REQUEST

Current Zoning: MUDD-O SPA (mixed-use development district, optional, site plan amendment)
Proposed Zoning: MUDD-O SPA (mixed-use development district, optional, site plan amendment)

SUMMARY OF PETITION

The petition proposes to combine four apartment buildings into two buildings without an increase the number of dwelling units. The site is currently developed with two new structure-parked apartment buildings and 17 garden-style apartment buildings dating from the 1960s.

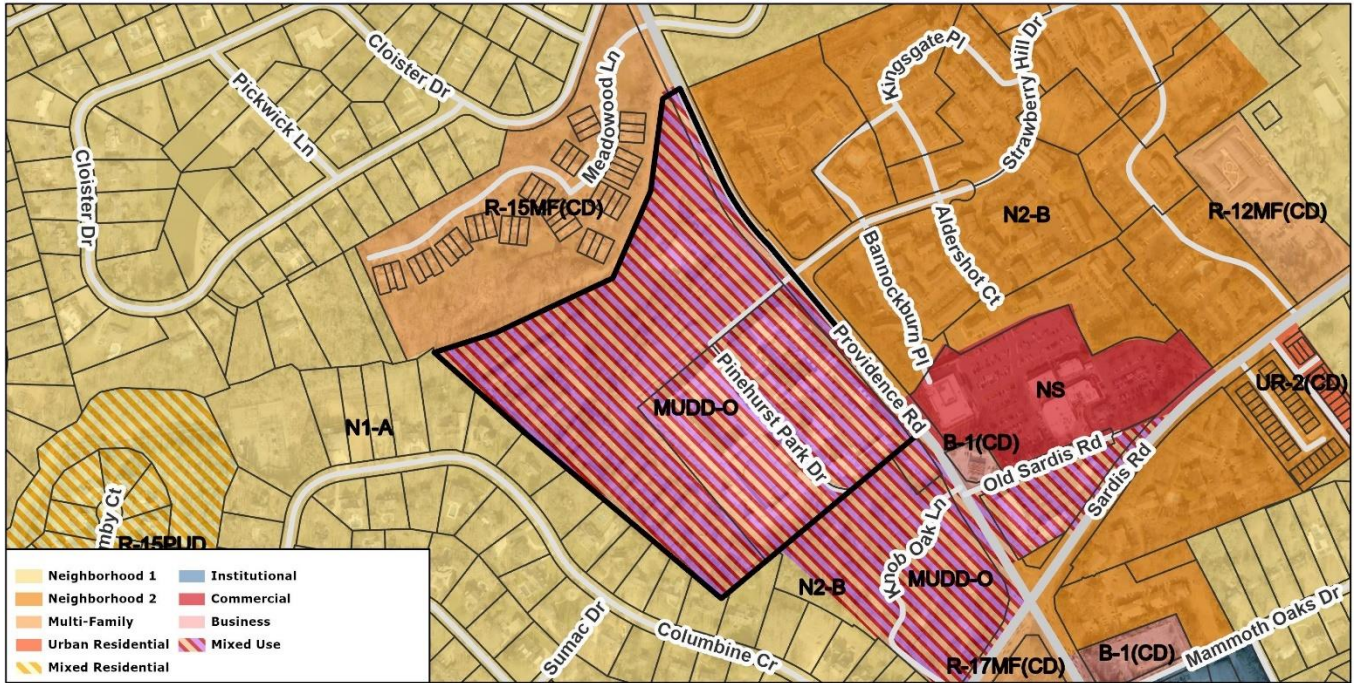
1. Mecklenburg County Park and Rec: The proposed greenway access easement must connect to the public street ROW to provide Mecklenburg County access to the greenway dedication area. This easement shall overlap with the private street between the public street ROW and the greenway area.

2. Stormwater Services Land Development: The rezoning plan proposes encroachments into SWIM and/or Post Construction Stormwater Ordinance stream buffers. Any increase of impervious area within such buffers may not be allowed and is not approved with the rezoning process. Please include the following note under Environmental Features: "Development within the SWIM/PCSO Buffer shall be coordinated with and subject to approval by Charlotte-Mecklenburg Storm Water Services and mitigated if required by City ordinance." Please note Stream Delineation Reports are subject to review and approval by Charlotte Storm Water Services.

3. Stormwater Services Land Development: Update label to say "100' SWIM and Post Construction Buffer." Buffer should be shown as extending 100' from top of bank.

4. Stormwater Services Land Development: add to note 8.d. under Environmental Features: "and mitigated if required by City ordinance."
5. Urban Forestry: Recommend changing the tree save conditional language. Based on what options are being used, tree save may be greater than 15%.

6. Urban Forestry: Tree save must meet min size requirements. Some of what is shown would not quality between the maintenance building and the water quality #2.
 7. Urban Forestry: While allowed, the amenity area within tree save would need to be accounted for at 150%
-
